BUS SYSTEM TEST PROCEDURES

2-WIRE NO. 1 ELECTRONIC SWITCHING SYSTEM

1.001 This addendum supplements Section 231-148-301, Issue 2.

Fig. 5—Peripheral Units Bus Test Waveforms

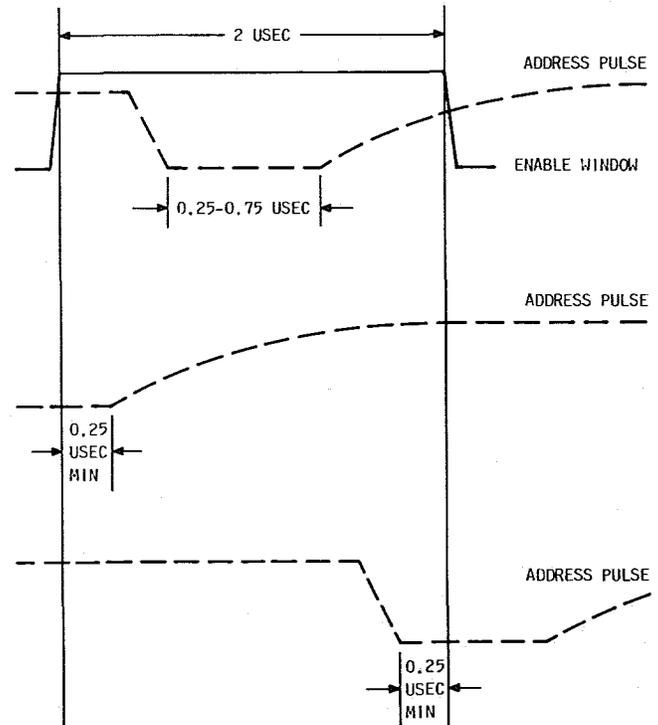
(4) The dual trace display must meet the following requirements: (See Fig. 5.)

- (a) The address pulse at the output of the cable receiver pack must have a duration between 0.25 microseconds and 0.75 microseconds.
- (b) At least 0.25 microseconds of the address pulse must be coincident with the enable window.
- (c) Address pulse rise and fall times are not critical as long as they do not exist in adjacent windows.

2.002 On Page 8, replace Fig. 5 with the following figure:
